STRUCTURAL EVALUATION OF
SHELDON ELEMENTARY SCHOOL
WEST CONTRA COSTA UNIFIED SCHOOL DISTRICT
(WCCUSD)

April 30, 2002

DASSE Design Project No. 01B300

Figure 1: School Layout Plan

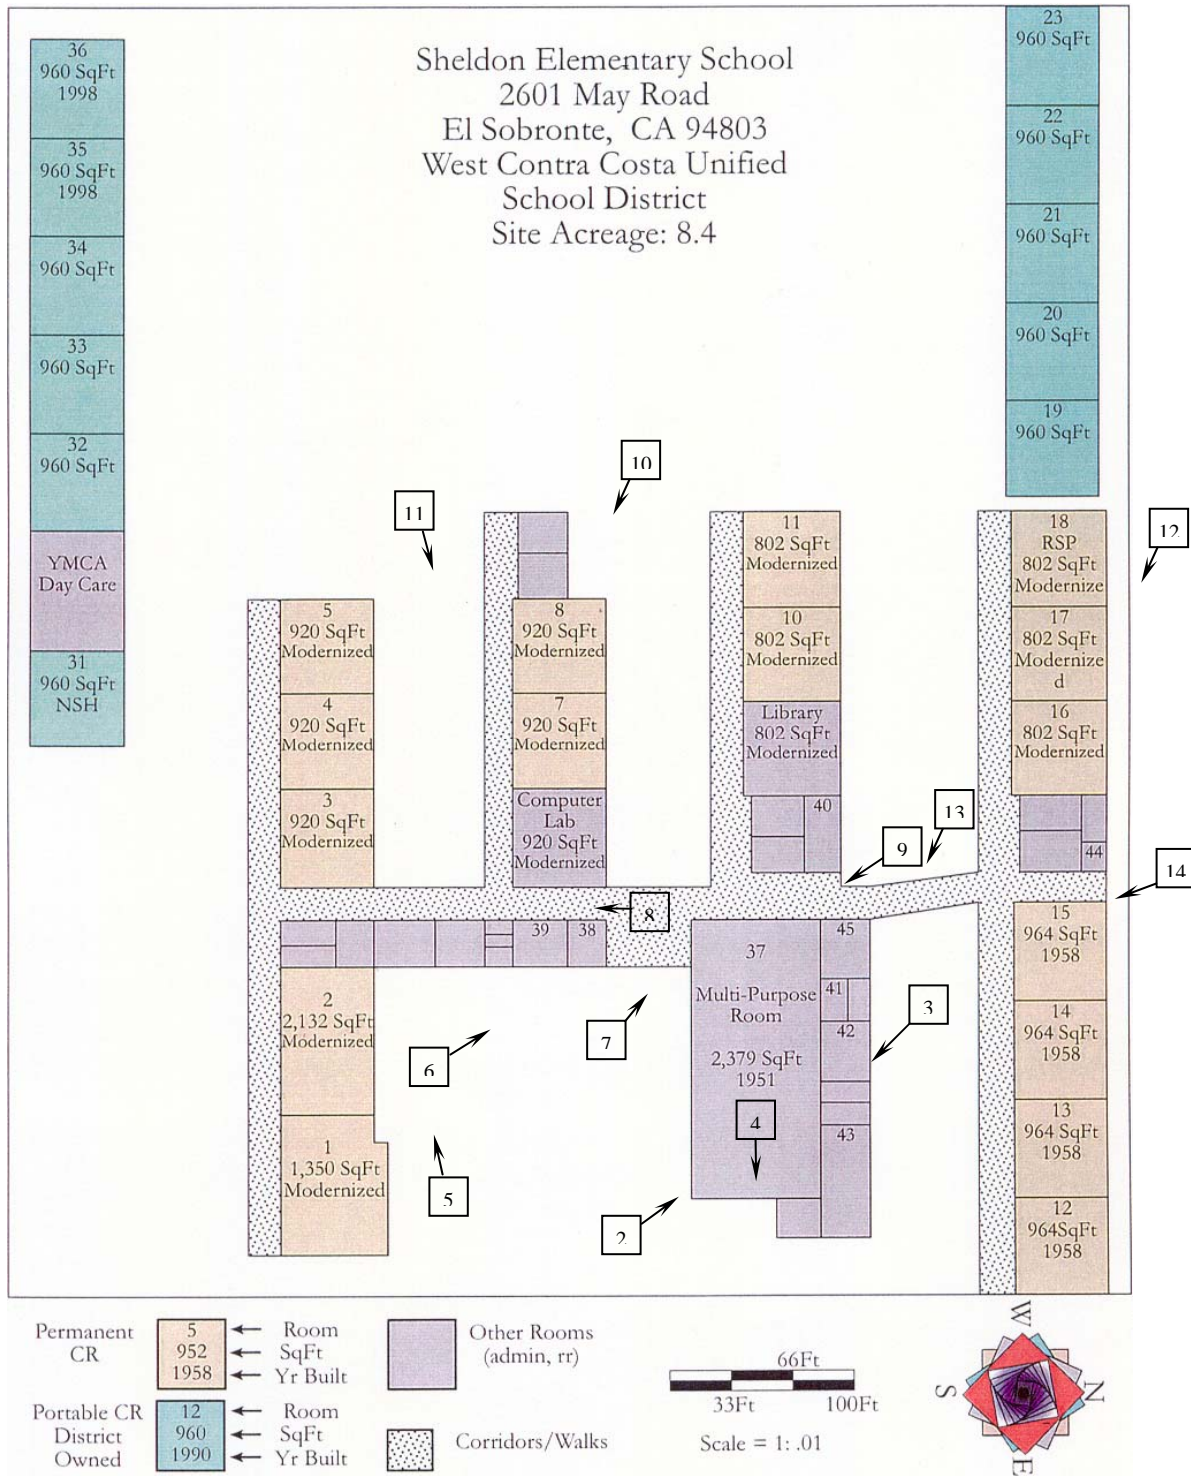
The school was built in 1951, 1955, and 1958. The buildings are one-story wood structures. There are eight main buildings (permanent structures) and twelve portable buildings of unknown age (see figure 1). The total square footage of the permanent structures is about 23,000 square feet.

Although many of the classrooms are connected to each other, there are eight separate buildings on the campus (see figure 1). The division of buildings is as follows:
